Drainage Proposals Report
for a
New Science Block at the Xavarian College,
Manchester
undertaken on behalf of
Xavarian College

Report Title:	Drainage Proposals Report for a New Science Block at the Xavarian College, Manchester
Report Reference:	10961 – Xavarian College – Science Block – Drainage Proposals - Rev 01
Client:	Xavarian College
Issue Date:	November 2023
Drafted By:	Kevin Tyldesley
Authorised By:	Loughlin O’Gorman

- 1.1 WML Consulting have been commissioned by the Xavarian College to provide a Drainage Proposals Report for a proposed development at their site at Lower Park Road, Manchester, M14 5RB.
- 1.2 In particular the report has been composed to respond to the drainage related planning condition (number 11) contained in Manchester City Council's planning approval notice ref. 137030/FO/2023, a copy of which can be found at appendix 01.

Proposed impermeable area plan

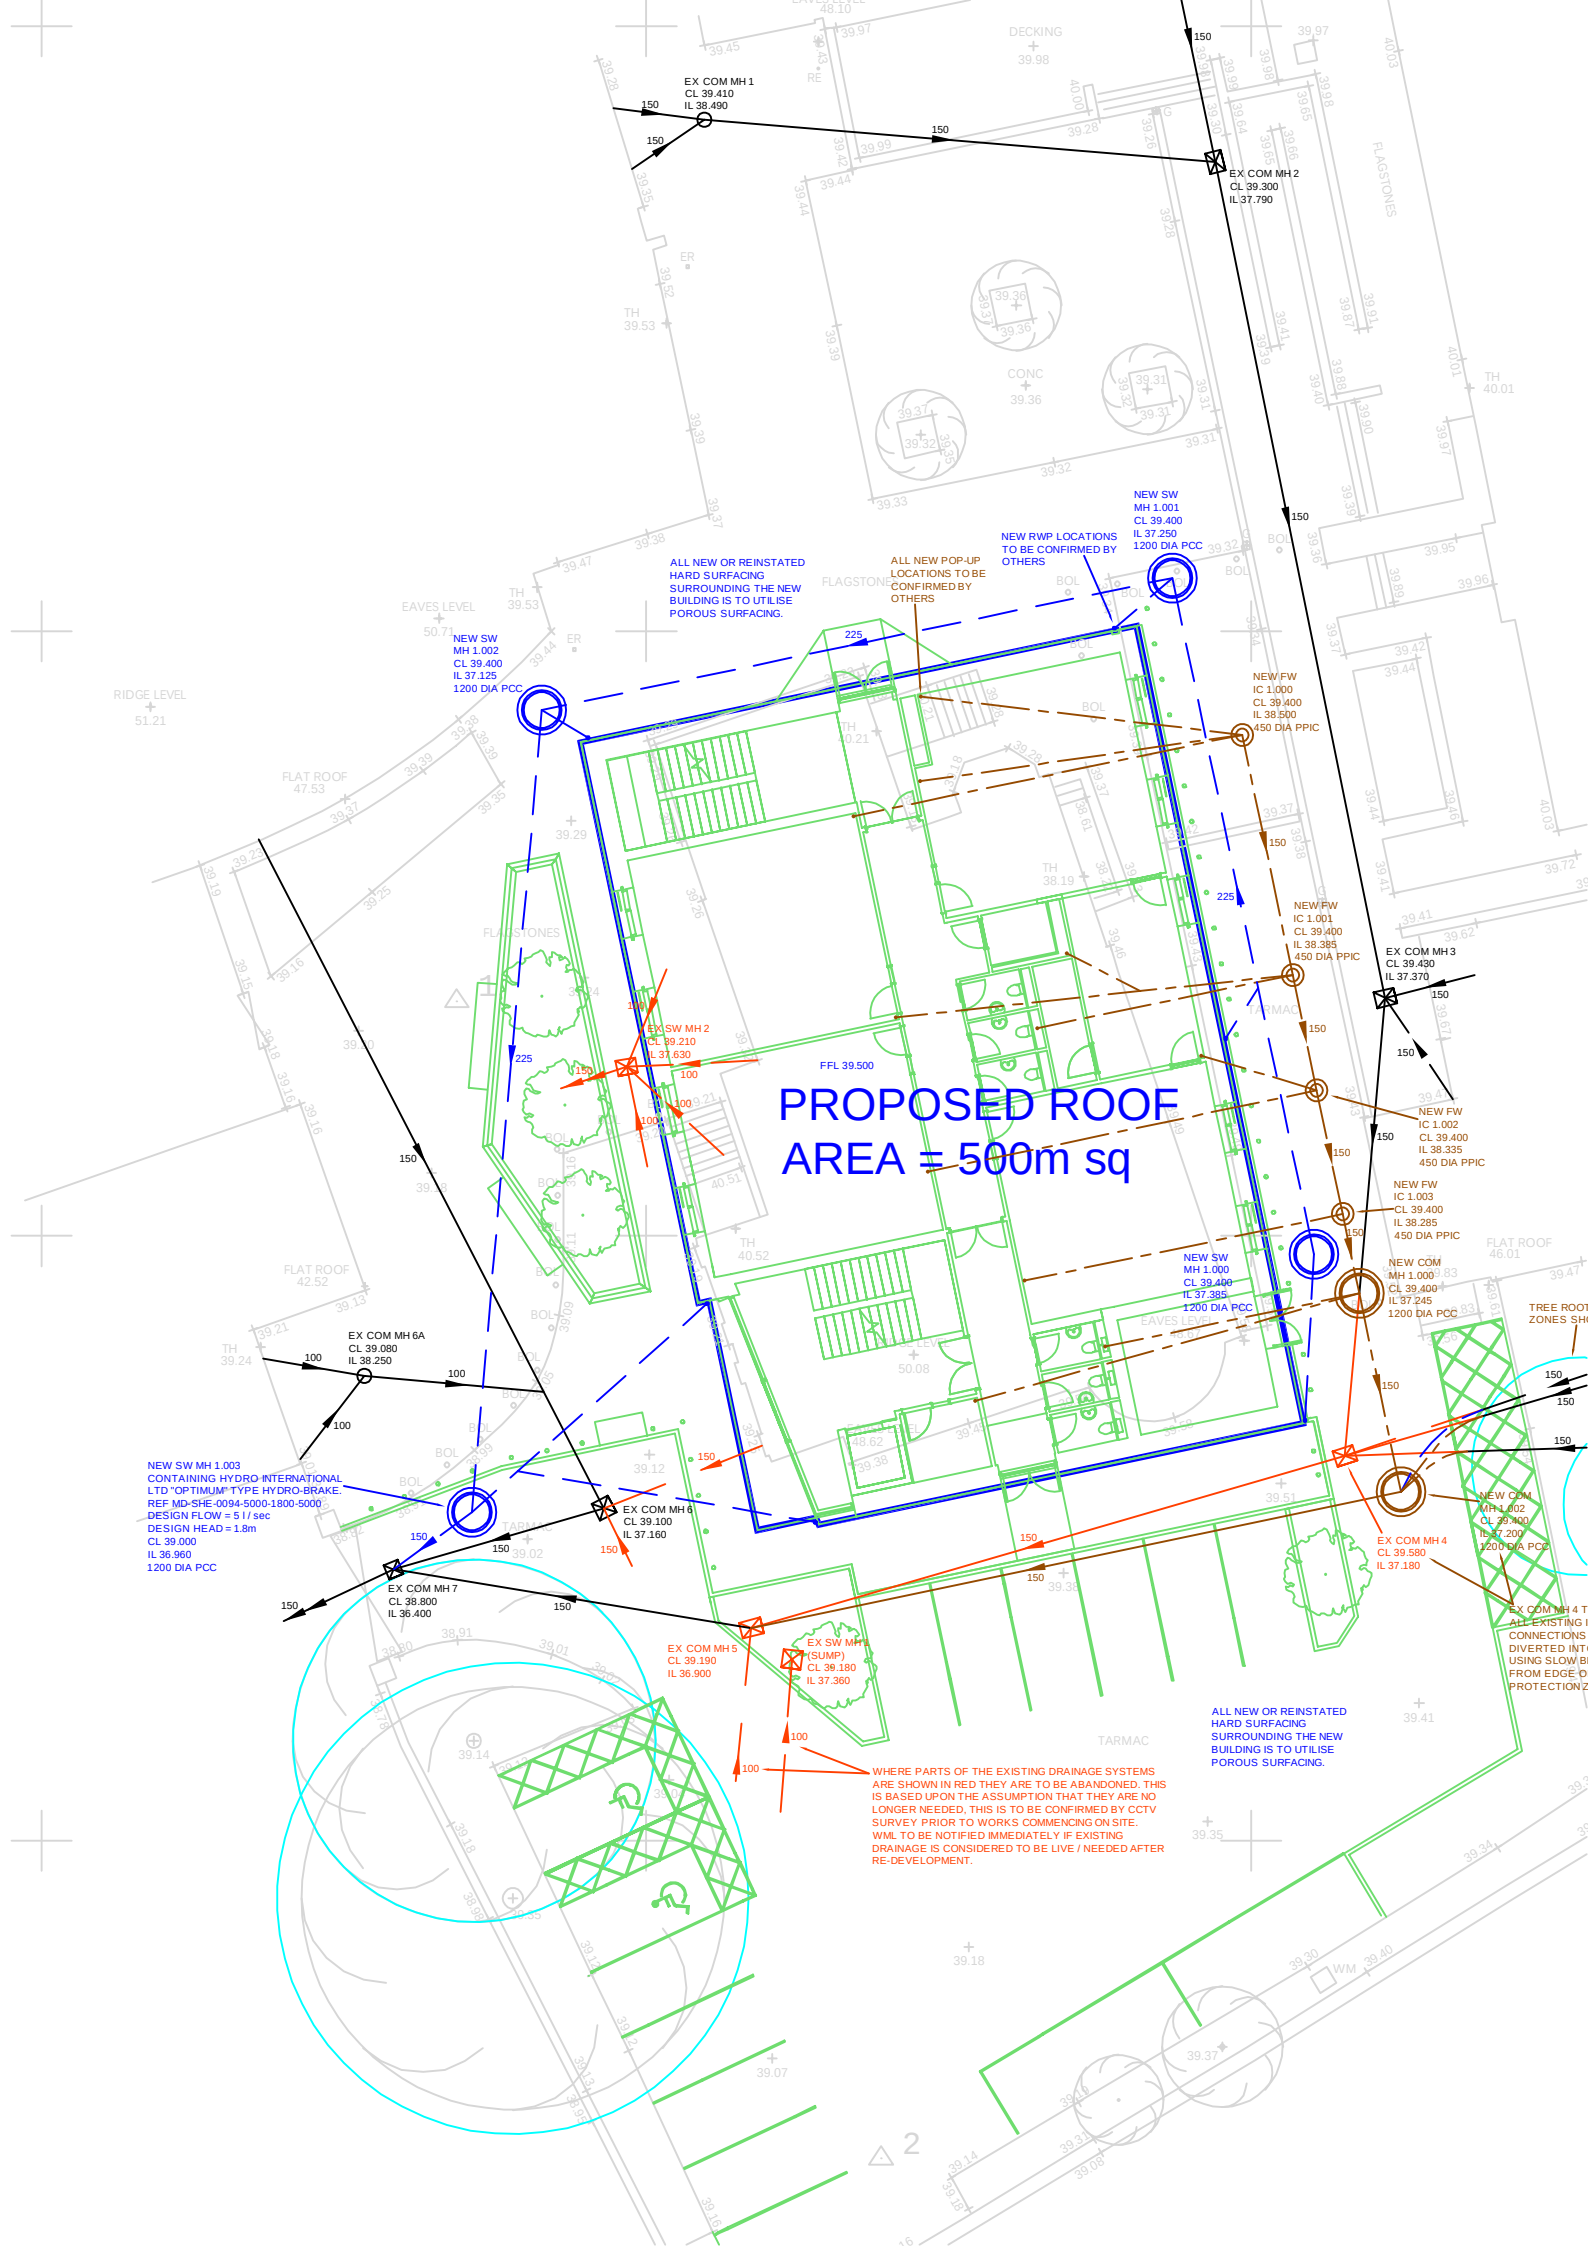
- An existing and proposed impermeable areas drawing to accompany all discharge rate calculations.
Refer to the existing impermeable area plan at appendix 05, upon which has been overlaid the outline of the proposed roof area of approx. 500m sq. As can be seen from this plan, the new roof area is proposed on an area that is currently all impermeable and positively drained. At appendix 06 can be found the proposed impermeable area plan.

- Runoff volume in the 1 in 100 year, 6 hours rainfall shall be constrained to a value as close as is reasonable practicable to the greenfield runoff volume for the same event, but never to exceed the runoff volume from the development site prior to redevelopment;
With reference to the existing impermeable area plan at appendix 05, it can be seen that in its existing form the site is wholly impermeable and positively drained. Whilst the re-development proposals will include areas of soft landscaping and permeable surfacing. Hence the volume of runoff post redevelopment will be less than under the existing scenario.
